Proposal for amending UN R13 Electric Park Brake warning

Industry proposal,
Amending ECE/TRANS/WP29/GRVA/2022/11
GRVA-13, May 2022

Case 1: Use of gradated Control by the driver (e.g. for secondary braking)

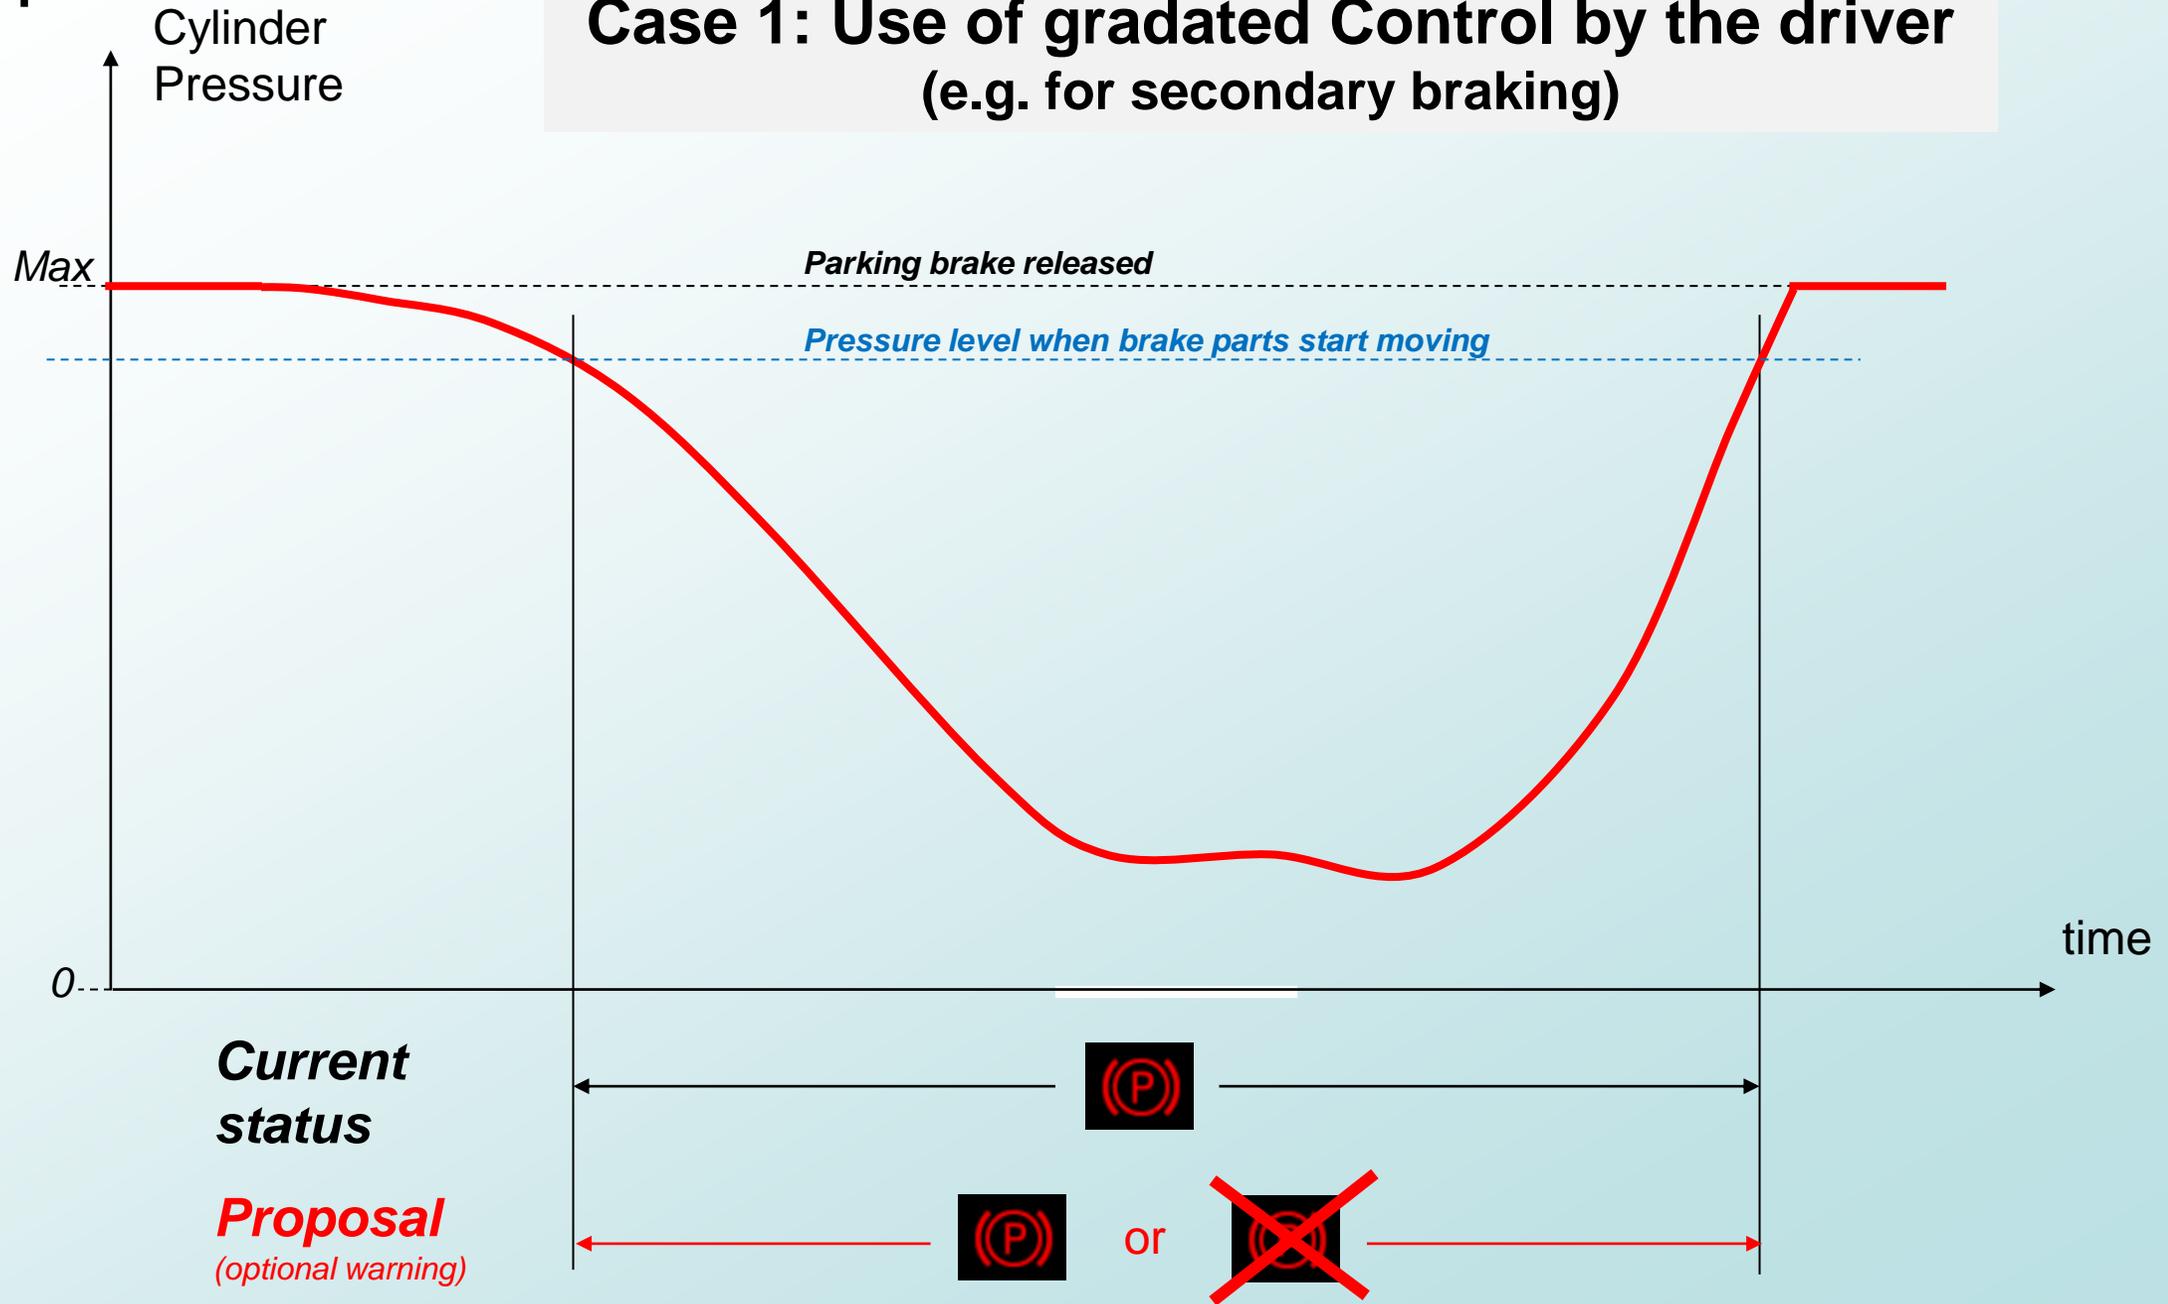
Principle

Case 2: Driver request for a full park brake application

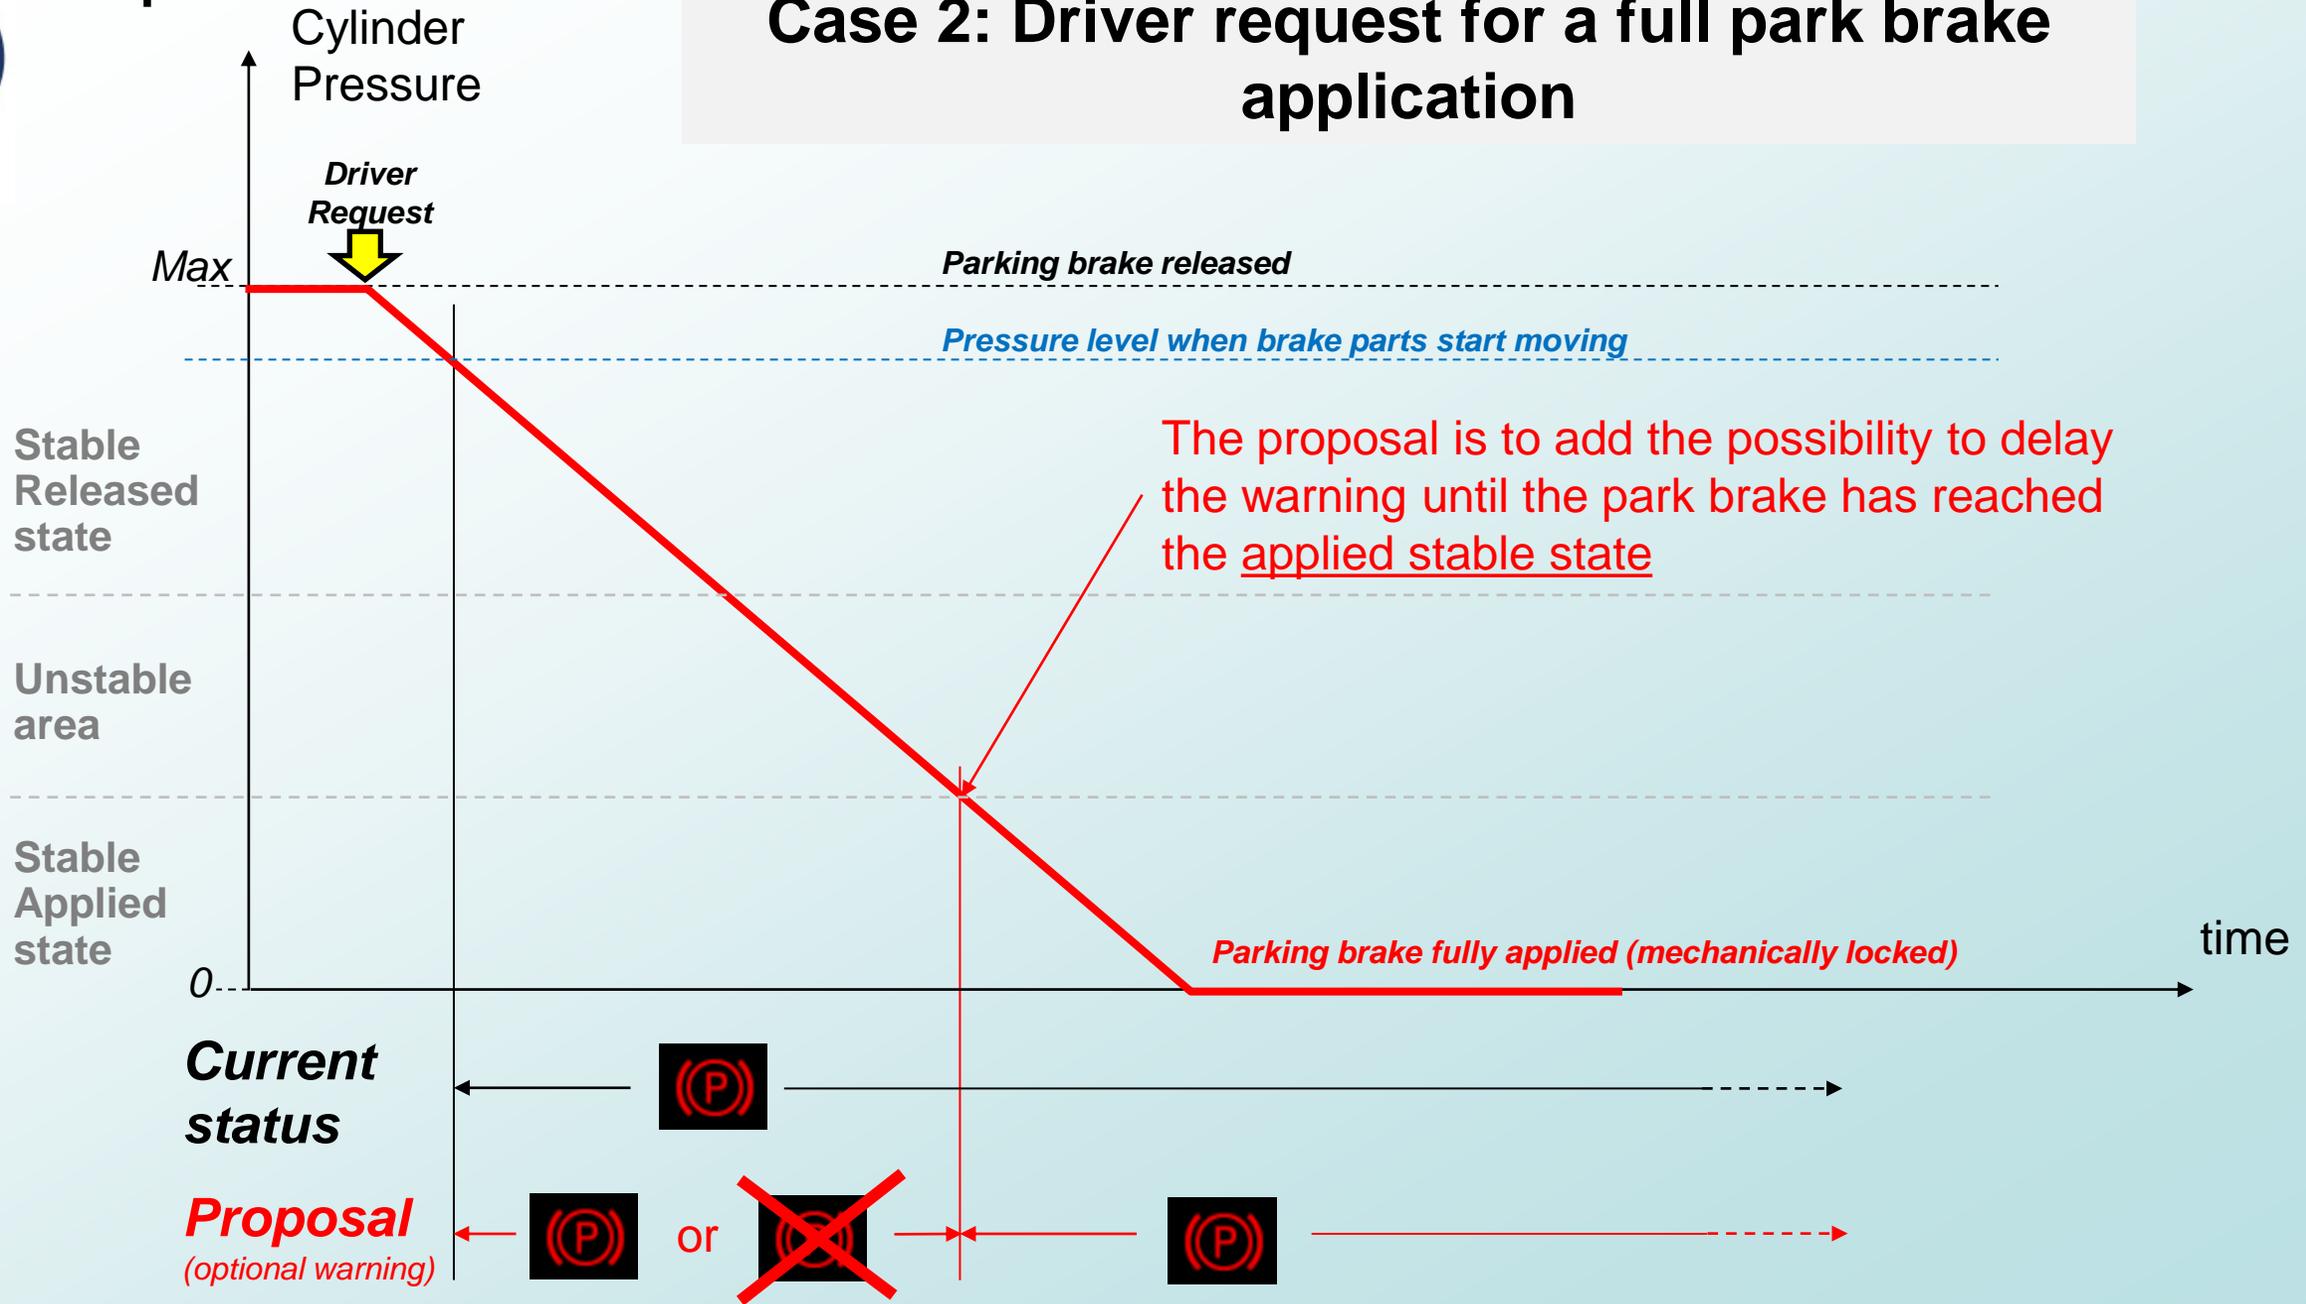
Principle
